Mandatory Update

Crankshaft Spacing

Models Affected:
942211

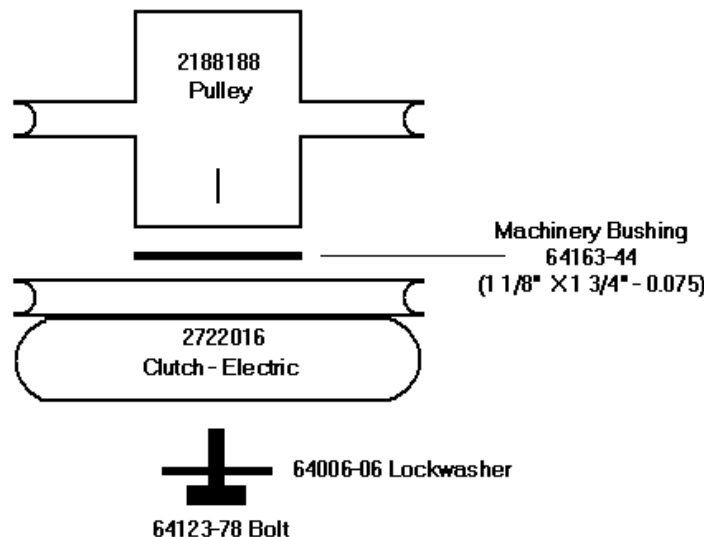
It has come to our attention that the crankshaft spacing may not be correct on the 218 ES units. Please update units in the field as soon as possible. Crated units can be updated at time of setup.

Remove the clutch mounting bolt from the center of the crankshaft. Remove the Clutch **2722016** and install a Machinery Bushing **64163-44** between the clutch and Pump Drive Pulley **2188188**. Reinstall the clutch and torque the clutch mounting bolt to 50 ft/lbs.
